Company	Trenz Electronic GmbH
PCN Number	PCN-20230616
Title	TE0741-04 to TE0741-05 Hardware Revision Change
Subject	Hardware Revision Change
Issue Date	2023-06-27

This change affects all Trenz Electronic TE0741 SoMs: TE0741-04*.

2.13 #13 Updated power diagram.

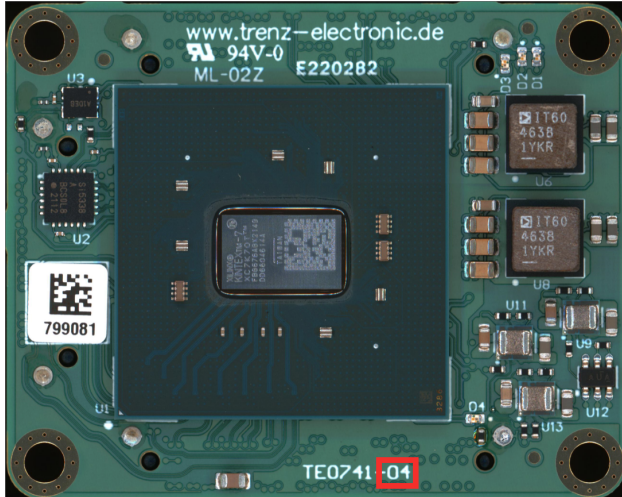
Type: Documentation Update

Reason: Documentation improvement.

Impact: None.
